**Request for Additional Information No. 547, Supplement 3**

**U. S. EPR Standard Design Certification**

**SRP Section: 03.07.02 - Seismic System Analysis**

**Question 03.07.02-76:****Open Item****Follow-up RAI 371, Question 03-07-02-67 (Supplement 24 Response)**

The sole purpose of this figure is to demonstrate dynamic compatibility between the dynamic and static models; it is not intended to be used as design information and it is not maintained as such.

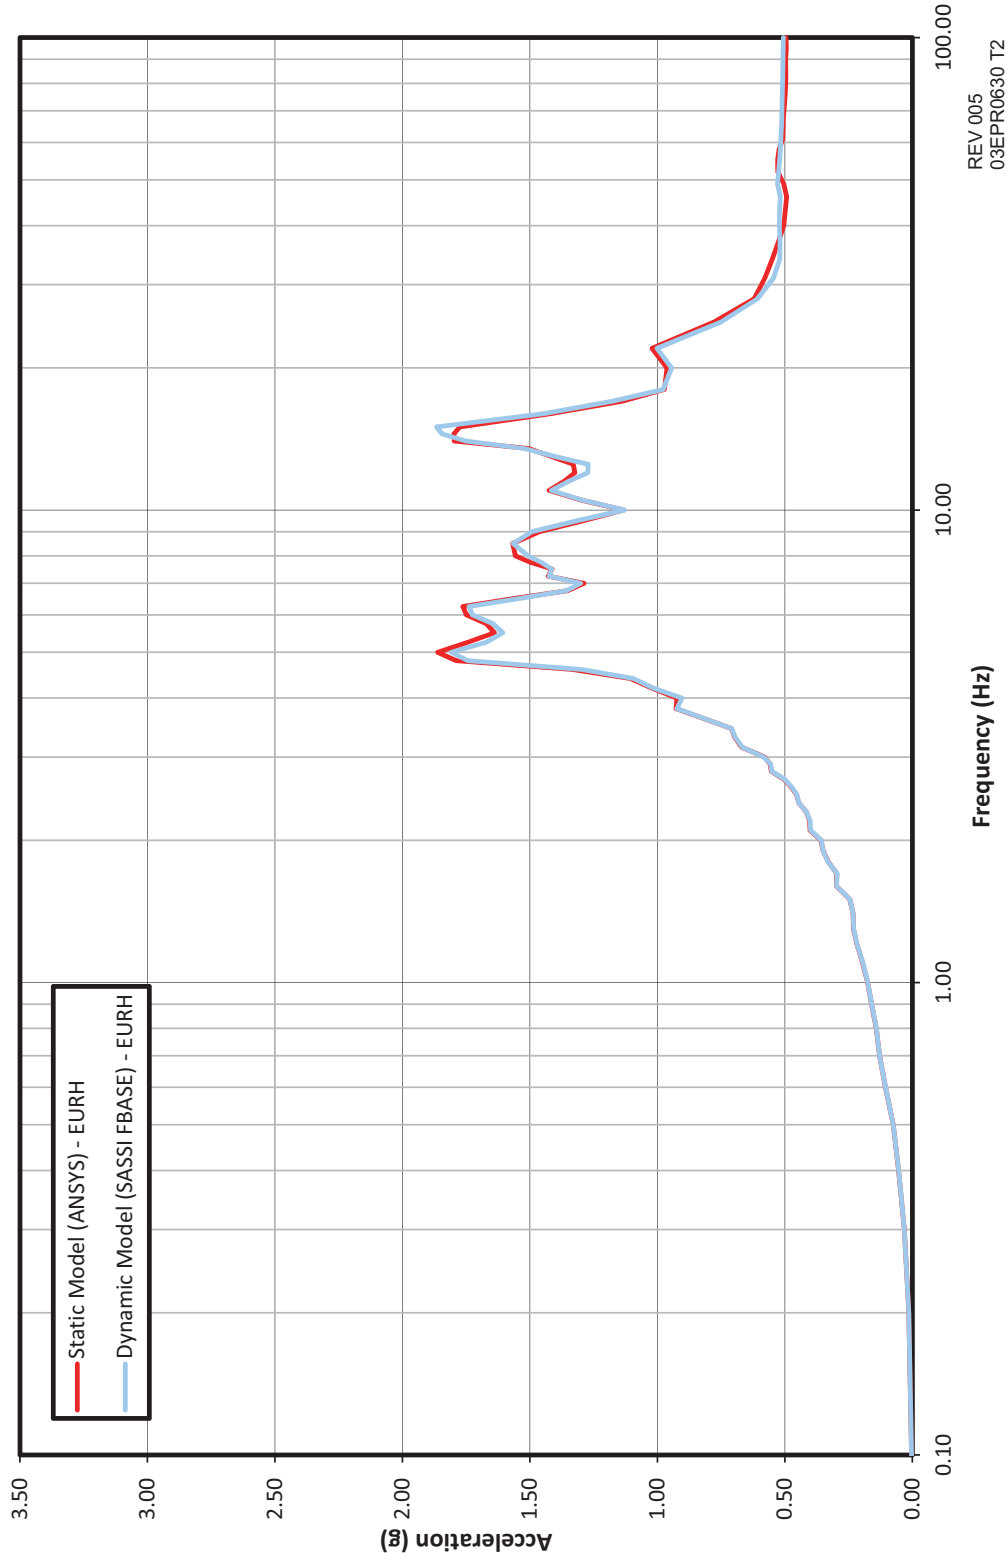
5. A comparison of Y-direction ISRS for Safeguard Building 1 (Figure 03.07.02-67-8) and X-direction ISRS for Safeguard Building 2/3 (Figure 03.07.02-67-19) at an elevation of 26 feet 3 inches shows that the static model results at frequencies less than 10 Hz to be 21 and 24 percent higher, respectively, than the dynamic model results. The envelope of the ISRS shown on FSAR Figures 3.7.2-81(Revision 3) for Safeguard Building 1 is about 5 percent

lower than the static result at a frequency of about 7.5 Hz. For Safeguard building 2/3 the envelope of ISRS shown on FSAR Figure 3.7.2-87 (Revision 3) exceeds both the static model and dynamic results. This might suggest that the comparison of static and dynamic results for the Safeguard Building at elevation 26 feet 3 inches are acceptable because the envelope of ISRS is approximately equal to or exceeds the static model result. However at frequencies below 10 Hz, the CSDRS for the EUR medium and soft soil cases exceed the CSDRS for the EUR hard soil case upon which the examples provided with the response are based. If the EUR medium or EUR soft time histories were used for the fixed base analyses it is likely the results at frequencies below 10 Hz would be higher than that provided with the response and might possibly exceed the envelope of the ISRS shown on FSAR Figures 3.7.2-81 and 87.

5. As described in Item (2), the BONI geometry from the static model has been incorporated into the dynamic model and new ISRS for Safeguard Building 1 (Figure 03.07.02-67-8) and X-direction ISRS for Safeguard Building 2/3 (Figure 03.07.02-67-19) at an elevation of 26 feet 3 inches have been generated. The ISRS comparisons are now more favorable. See updated FSAR figures 3.7.2-17 through 3.7.2-34 in the attached mark-up for Safeguard Building ISRS comparisons.

Figure 3.7.2-38—Static FEM vs. Dynamic FEM Spectrum Comparison at Elev. +23 ft, 7-1/2 in (+7.20m) - Fuel Building, 5% Damping, X-Direction

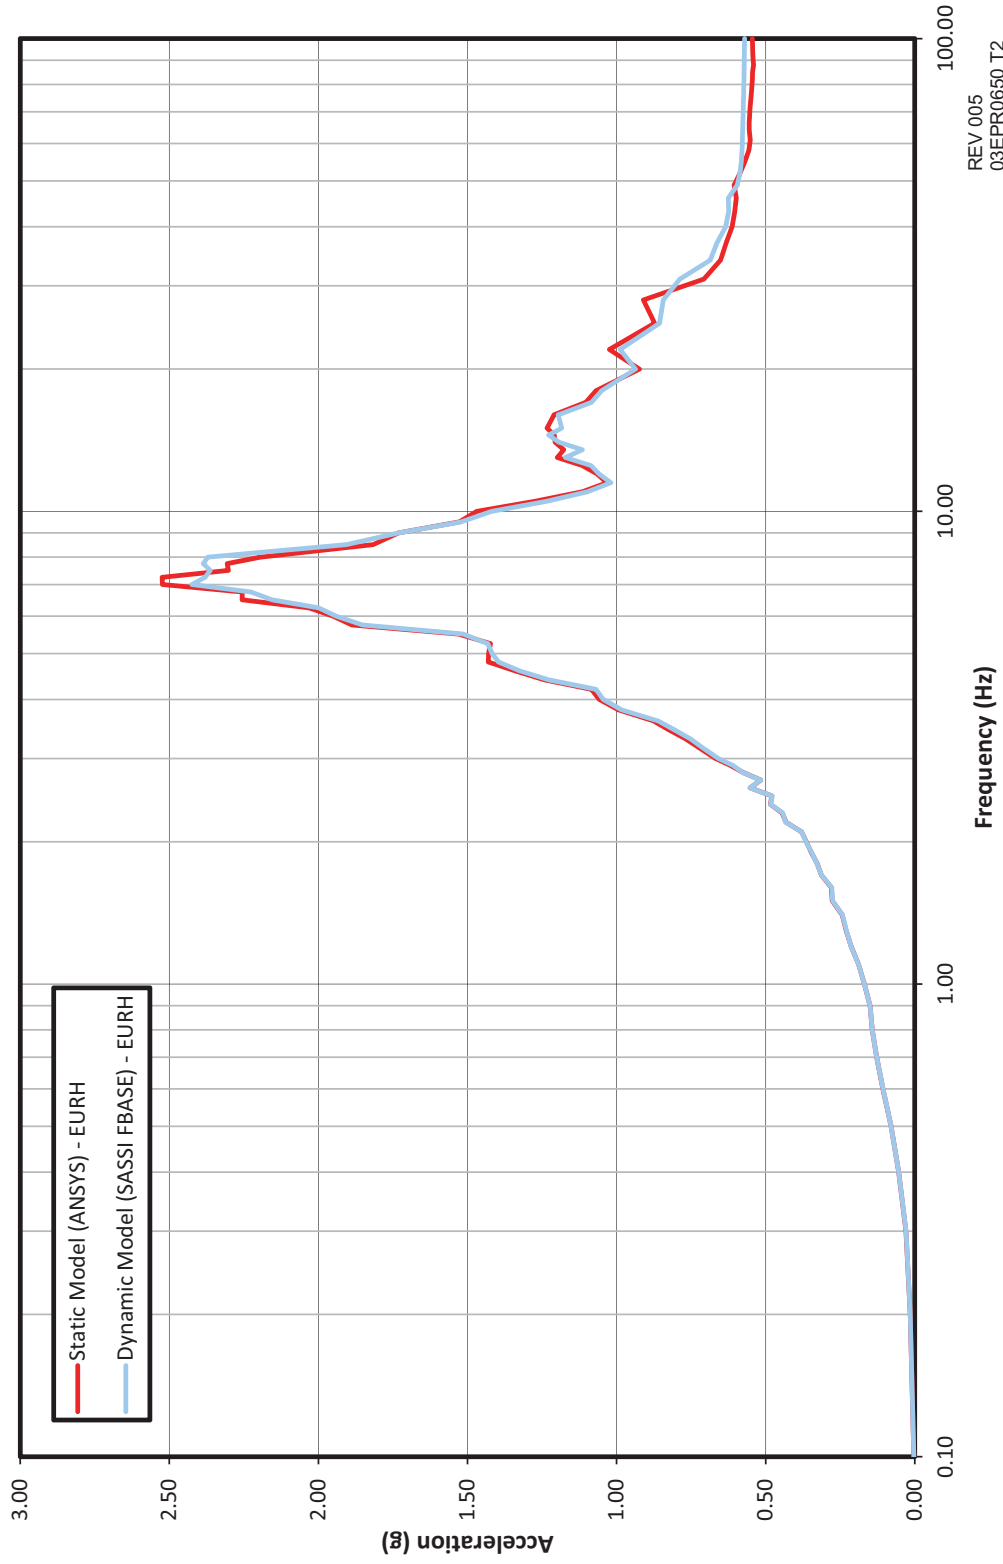
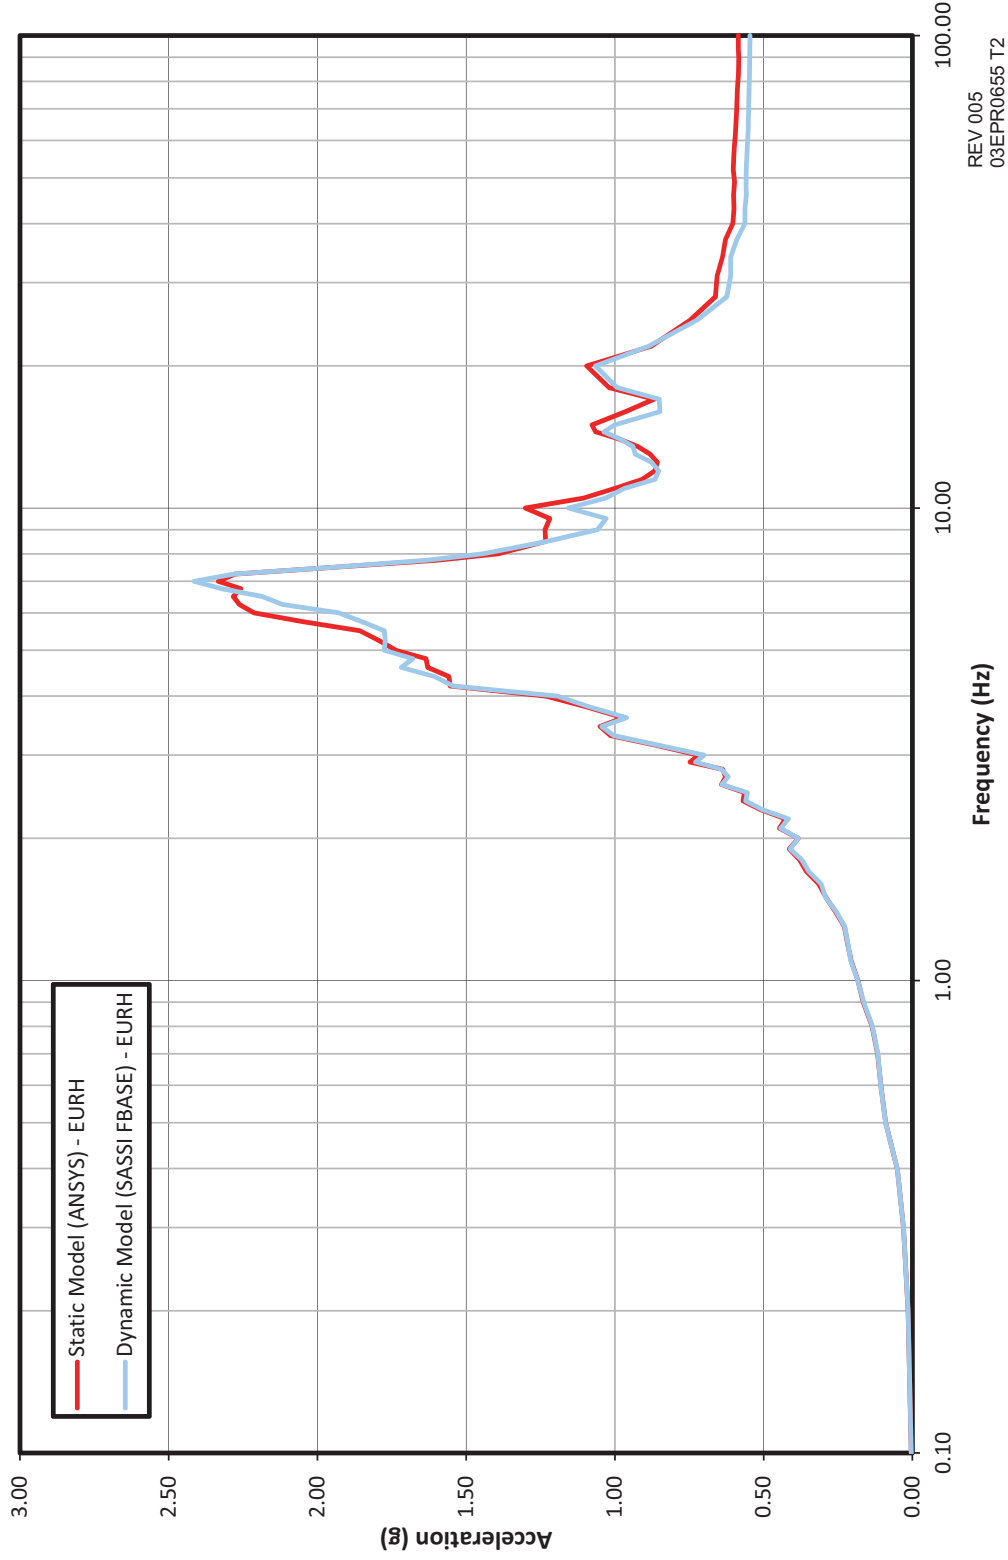
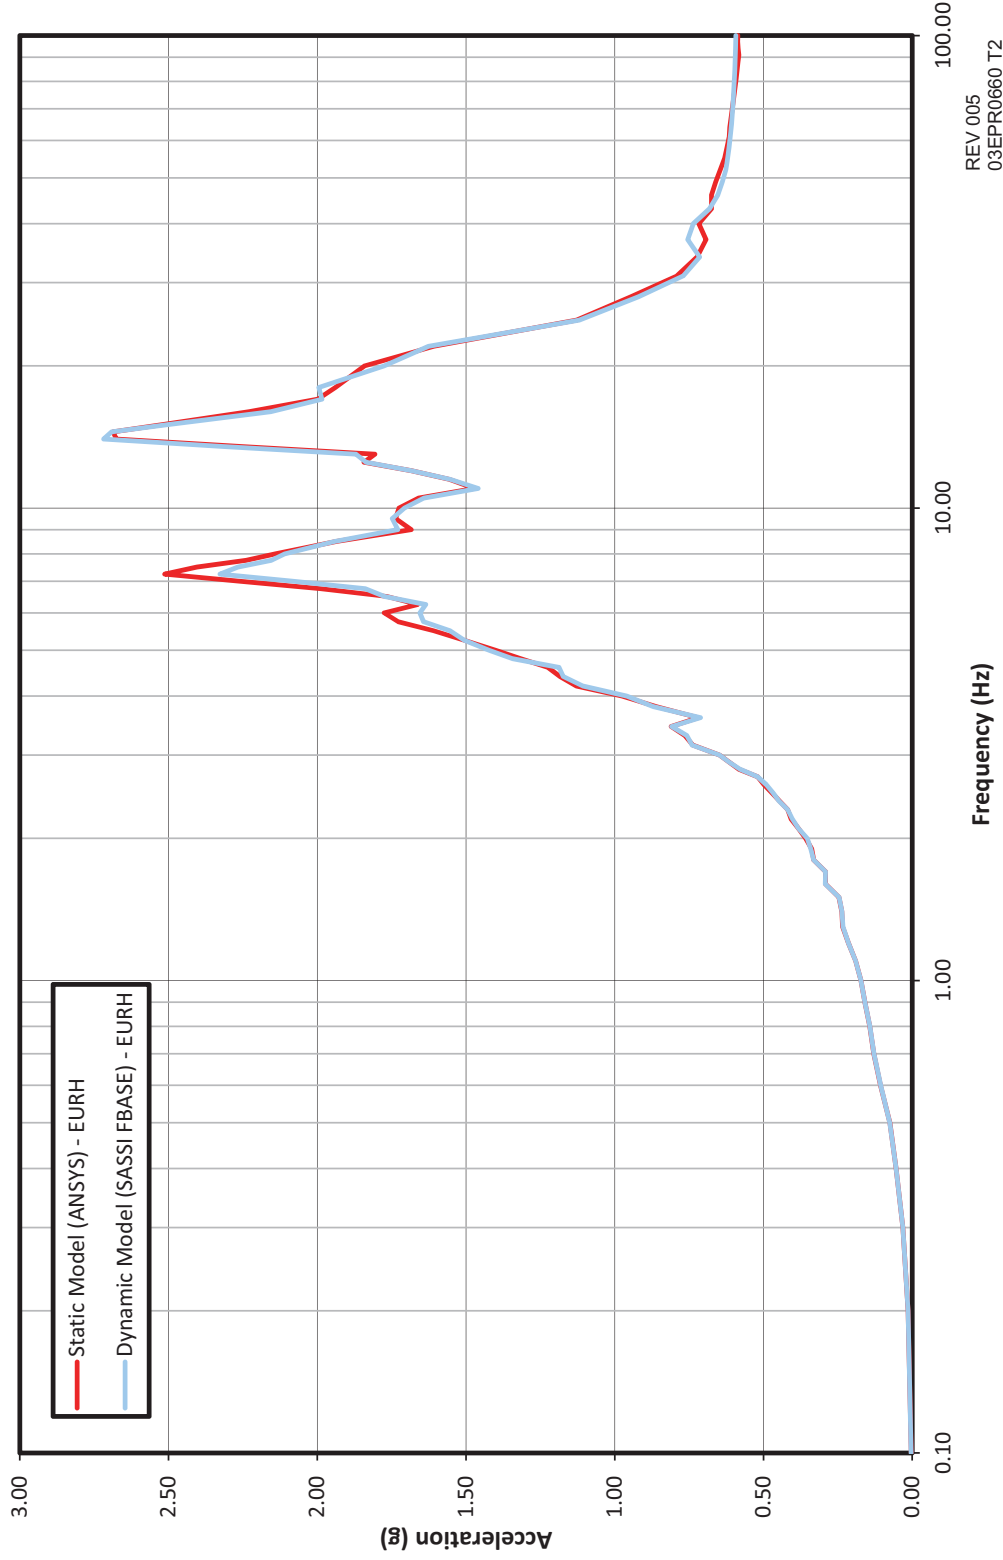
4. A comparison of ISRS for the Fuel Building at elevation 23 feet, 7  $\frac{1}{2}$  inches for the Z direction (Figure 03.07.02-67-27) shows the static model result at a frequency of about 7 Hz to be 15 percent higher than the dynamic model result.

4. As described in Item (2), the BONI geometry from the static model has been incorporated into the dynamic model and new ISRS for the Fuel Building at elevation 23 feet, 7  $\frac{1}{2}$  inches for the Z direction (RAI 371 Figure 03.07.02-67-27) have been generated and the ISRS comparisons are now more favorable. See updated FSAR figures 3.7.2-38 through 3.7.2-40 in the attached mark-up for elevation +23 feet, 7  $\frac{1}{2}$  inches. In addition, see updated FSAR figures 3.7.2-35 through 3.7.2-37 in the attached mark-up for another comparison of Fuel Building ISRS.
